MICROLIGHT AIRWORTHINESS APPROVAL NOTE

MAAN NO: 2283

TITLE: Microlight Airworthiness Approval Note 2283: inspection and modification of the elevator anti-balance tab control mechanisms

APPLICABILITY: UK Savannah aircraft fitted with bungee pitch trimmer (Mandatory Modification 12)

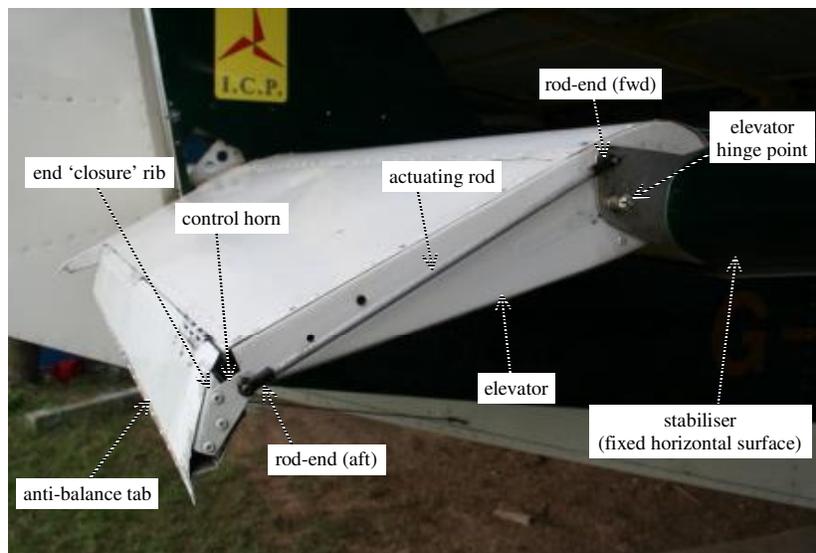
UK Savannah aircraft have two anti-balance tabs fitted to the trailing edge of the elevator (one on the port side and one on the starboard side). Each anti-balance tab has its own control mechanism located at the outboard end of the elevator and protected by a fairing. Figure 1 shows the control mechanism for the starboard anti-balance tab.

- To port, the end 'closure' rib fractured so that the control horn was no longer positively attached to the anti-balance tab. Figure 2 shows the fractured end 'closure' rib.
- To starboard, a rod-end on the actuating rod failed. The rod ends are plastic retaining a brass bush. The plastic had enlarged so that the bush was no longer retained.

Within 3 months of the effective date of this service bulletin the plastic rod-ends must be replaced with metal rod-ends. The metal rod-ends are provided by Sandtoft Ultralight Partnership together with fitting instructions. This modification does not stop the requirement for careful pre-flight inspection.

- The rod-ends have been fitted in accordance with the fitting instructions and to a satisfactory standard. In particular: the threaded rod and aluminium tube are in satisfactory condition; the aluminium tube ends are cut square; the threaded rod is not cut too short (insufficient exposed length to satisfactorily screw the rod ends onto – minimum 8mm at each end) or too long (aluminium tube is loose with rod ends screwed fully down).
